service bulletin

Bulletin No. 2002-17
Jet Drive No. 2002-09

Key Switch Harness (859722A16) - Sea Doo Boats

00162

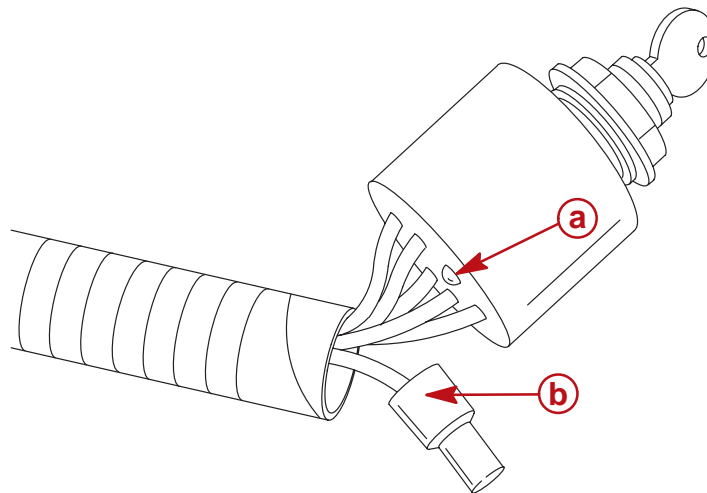
There is a very remote possibility for damage to the powerhead PCM and the steering helm low speed control sensor using the key switch harness in the boats listed above.

After gaining access to the back of the ignition switch, please observe that there are two similar wires coming out of the switch. One wire is a black wire with a yellow tracer and the other is a **yellow wire with a black tracer**. The correction is cutting the **yellow wire with a black tracer** as close to the ignition key switch as possible.

DO NOT cut the black wire with a yellow tracer that is attached to the ignition switch. The ability to turn off the engine using the key switch will be lost. The lanyard will still shut the engine off when pulled off its switch.

Apply RTV sealant (Loctite 5145 or equivalent) over the exposed end of the wire on the switch. Fill a wire nut with RTV sealant and install on the other end of the cut wire.

NOTE: Do not use an architectural grade or household window/door silicone sealant. These sealants contain acetic acid which is corrosive to electrical components.

- a** - Cut end of wire on switch
- b** - Wire nut
